**Model Name: GA-H61M-USB3-B3** Revision 1.11

Title			Cover Sheet
Size	Document Number	GA-H61M-USB3-B3	Rev
Custom			1.11
Date:	Monday, May 09, 2011	Sheet	1 of 35

BOM & PCB MODIFY HISTORY			
Title	Document Number		
Size	GA-H61M-USB3-B3		
Custom	Rev 1.11		
Date	Monday, May 09, 2011	Sheet	2 of 35

Title			
PCIE X 1/CLK GEN			
Size Custom	Document Number	GA-H61M-USB3-B3	Rev 1.11
Date:	Monday, May 09, 2011	Sheet 15 of 35

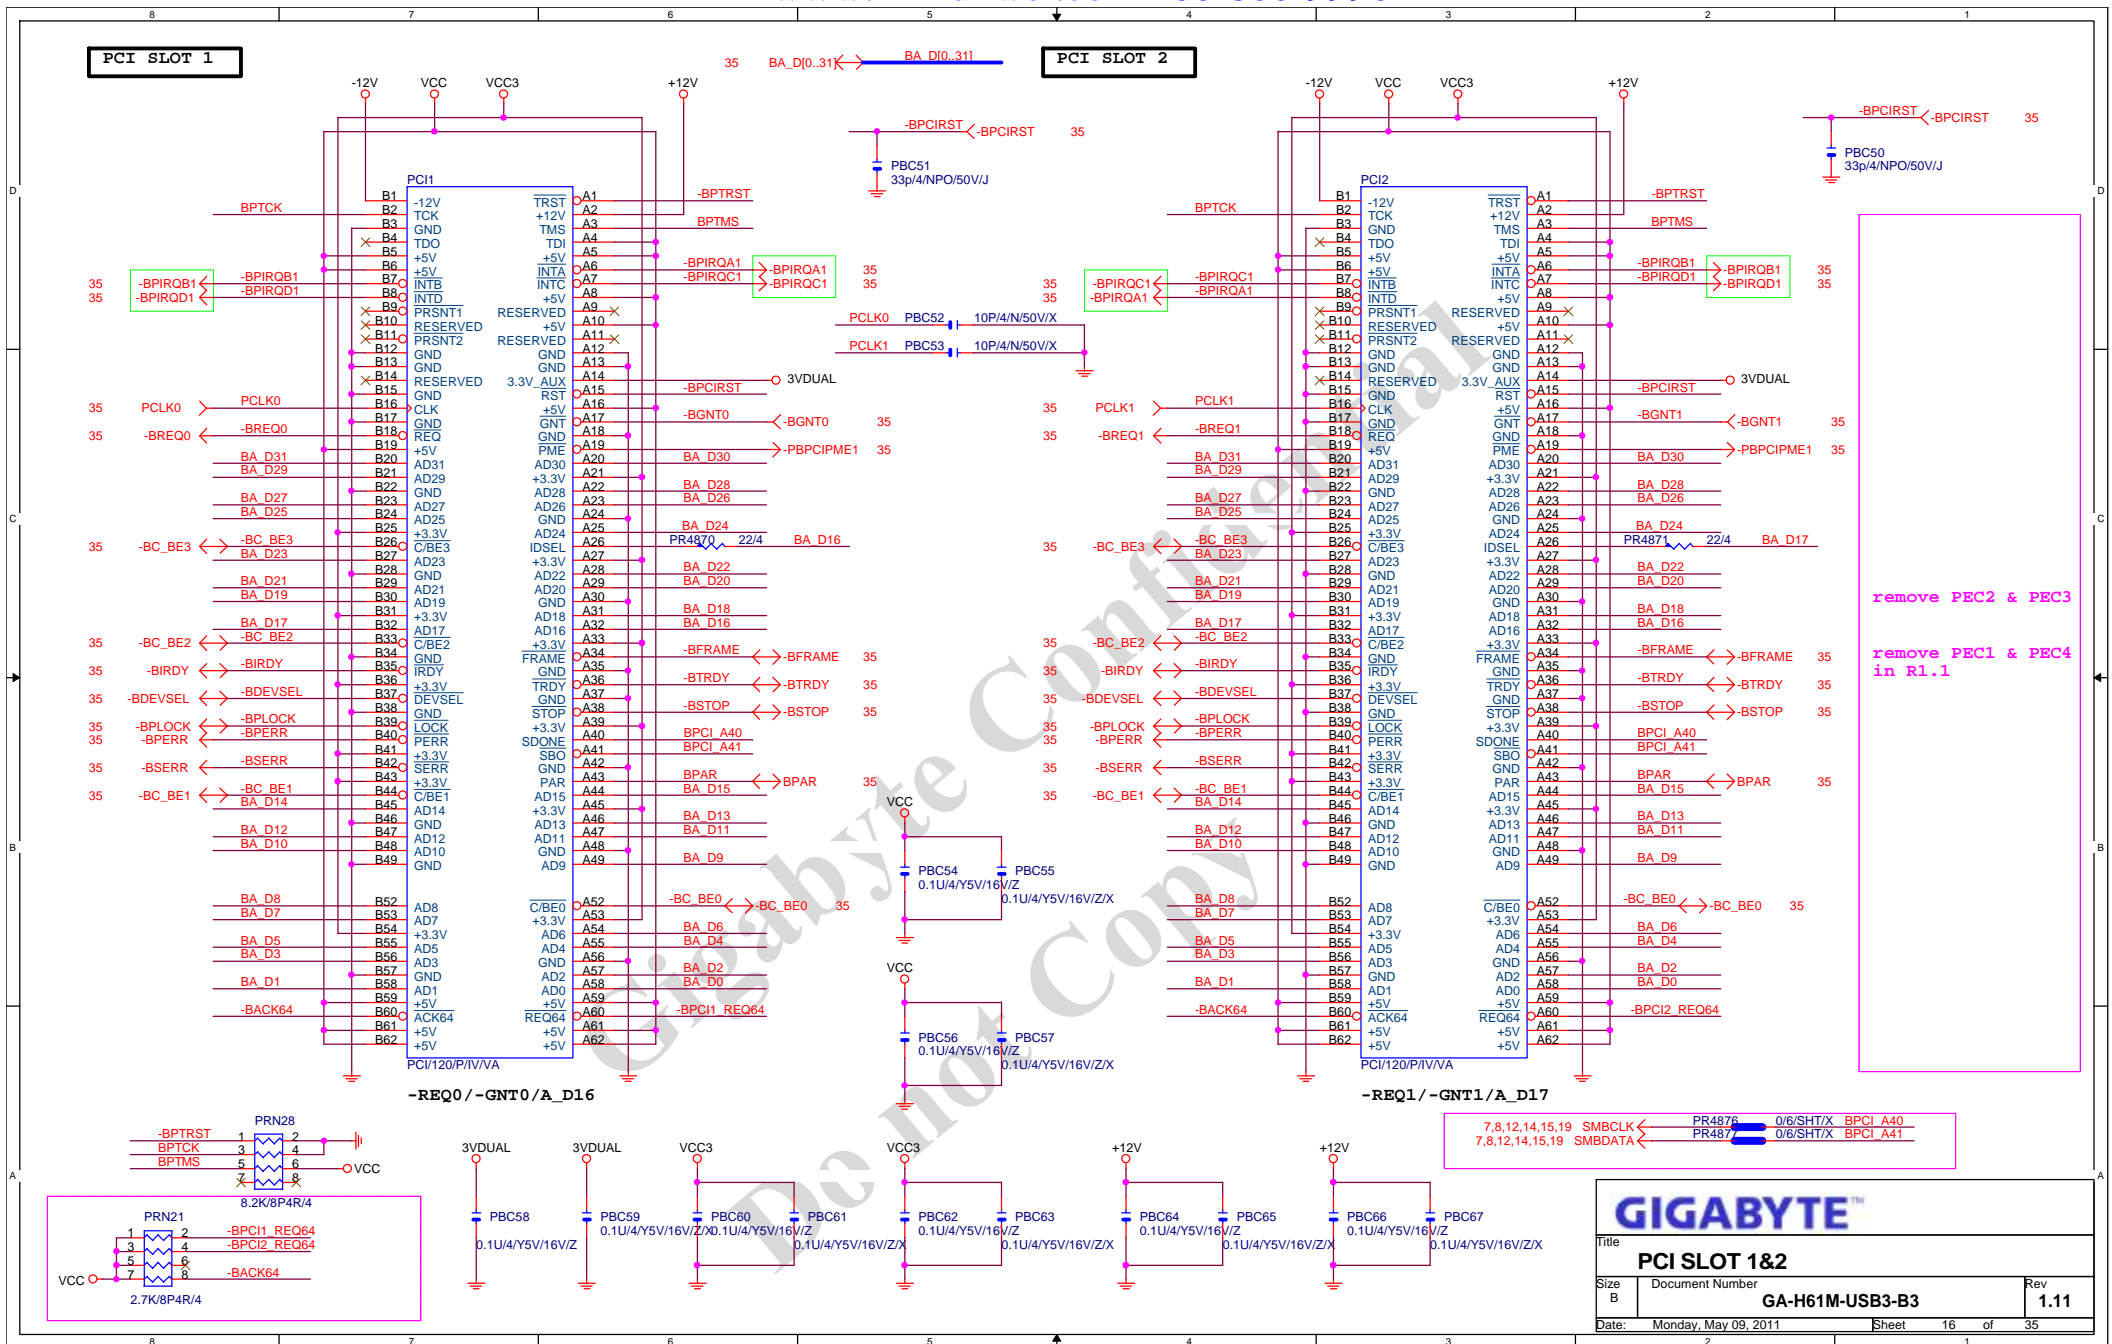
PCIEX4 change to PCIEX1

R323 10K change to 8.2K

R322 10K change to 8.2K

R320 10K change to 8.2K

R319 10K change to 8.2K

10K change  
to 8.2K

DUAL BIOS

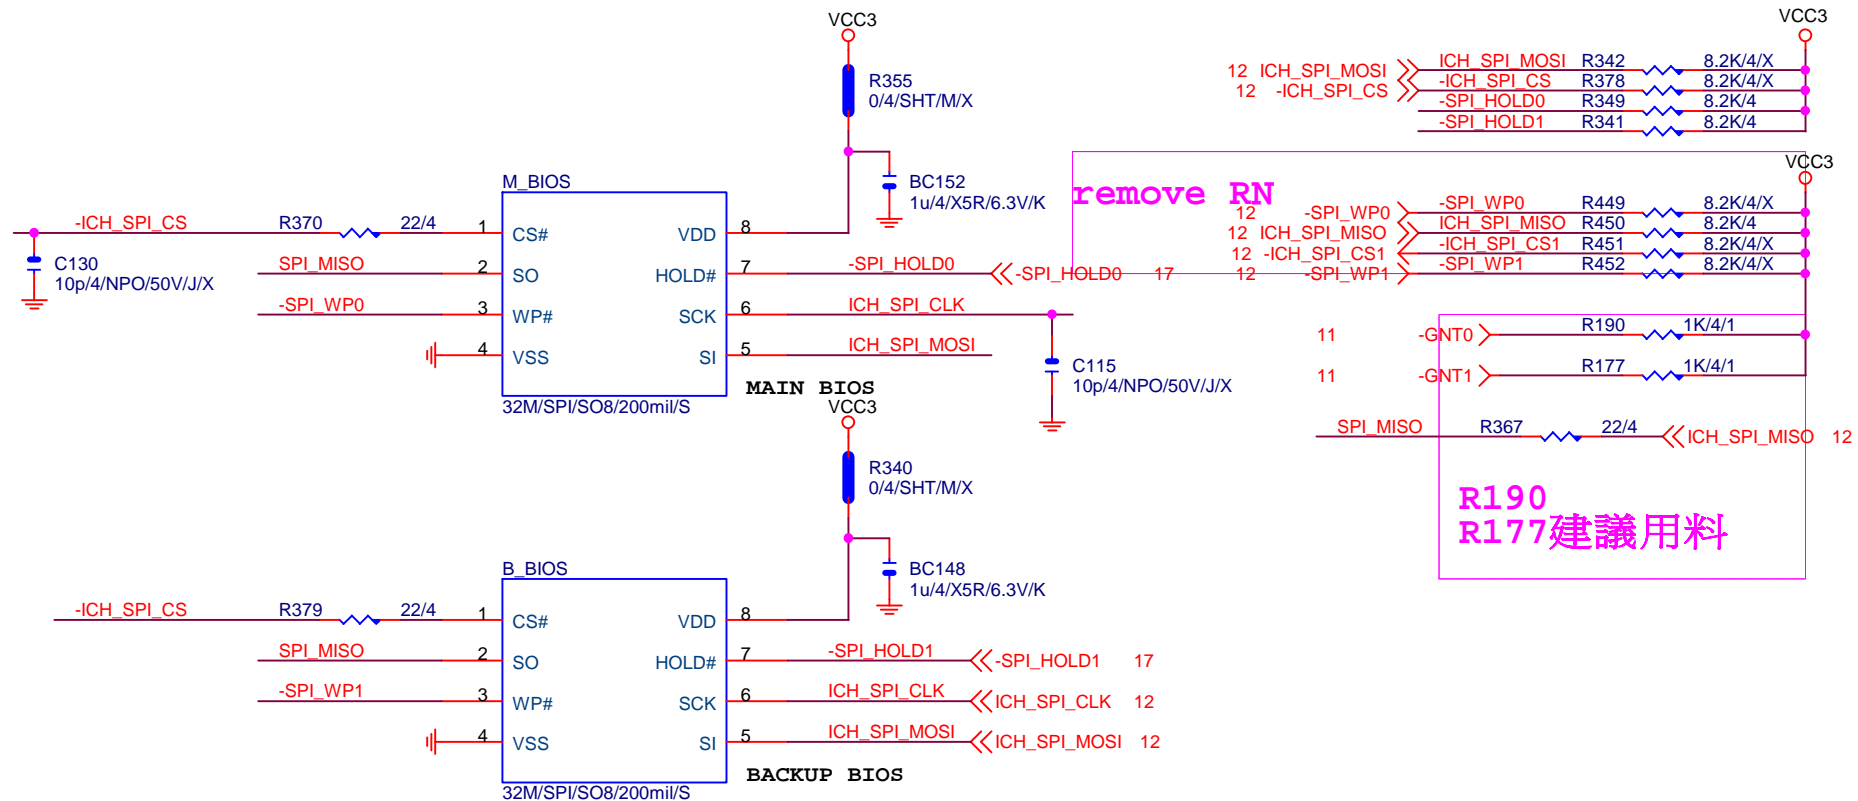
R349 R341 改上件 for ITE 8728 DX

Title	CPU_VTT PWM_ISL95870CRZ	Rev	1.11
Size	Document Number	GA-H61M-USB3-B3	
Cur	Cur		
Date	Monday, May 09, 2011	Sheet	28 of 36

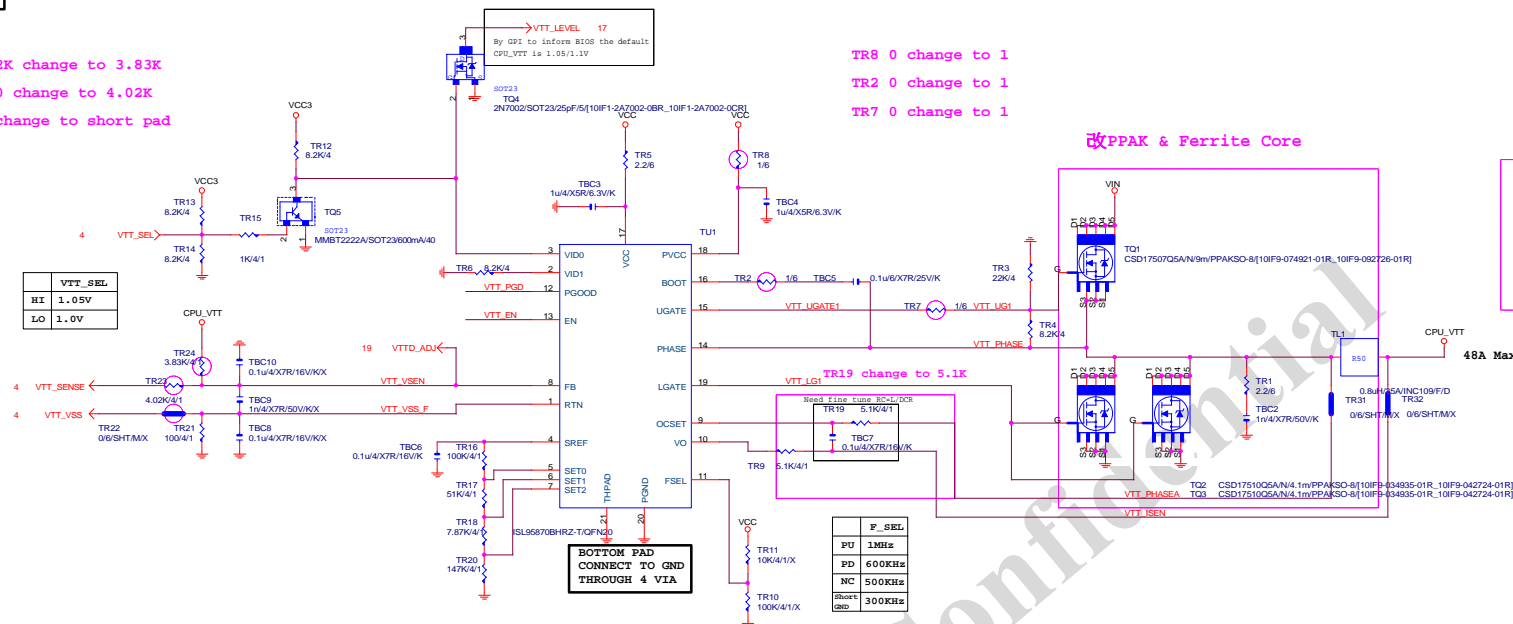
TR23 2K change to 3.83K  
TR23 0 change to 4.02K  
TR22 change to short pad

TR8 0 change to 1  
TR2 0 change to 1  
TR7 0 change to 1

Gigabyte Technology		
CPU CORE VR-1		
File	Document Number	Rev
	GA-H61M-USB3-B3	1.11
Size	Custom	
Date	Monday, May 09, 2011	Sheet 29 of 35

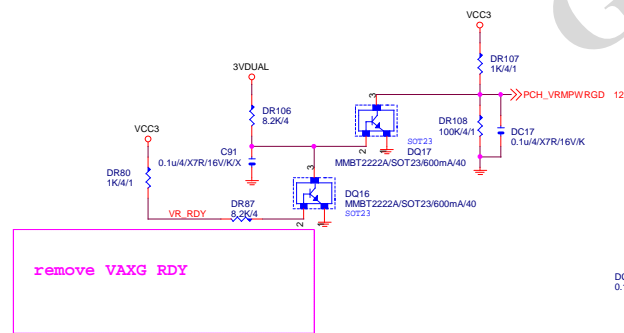
DR85 150 change to 51  
 DR69 6.8K change to 11K  
 DR82 0 change to 10  
 DR62 2.1K change to 1.1K  
 DR65 1.6K change to 1.1K  
 DR57 100 change to 8.2K  
 DR102 100 change to 8.2K  
 DR54 short change to 750  
 DR103 short change to 1K  
 DR91 6.8K change to 10K  
 DR100 3.3K change to 1K  
 DR69 11K change to 20K  
 DR54 750 change to 1.2K

DR84 56.2 change to 51  
 DR92 2.1K change to 1K

DR52 16.2K change to 24.9K

remove VAXG RDY

DR46 DR48 DR45 DR47 change to 10  
 DR86 change to 750

Title			CPU CORE VR-2
Size	Document Number	GA-H61M-USB3-B3	
Custom		Rev	1.11
Date:	Monday, May 09, 2011	Sheet	30 of 35

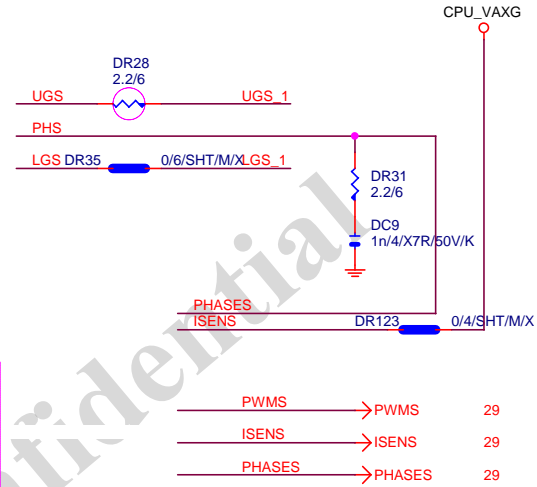
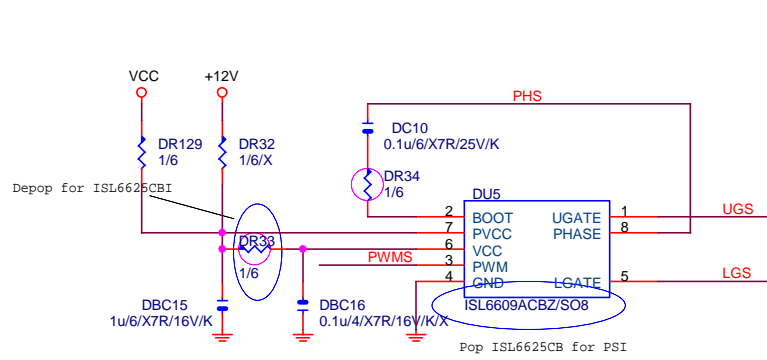
DR33 0 change to 1  
DR34 0 change to 1  
DR28 0 change to 2.2

## 改PPAK & Ferrite Core
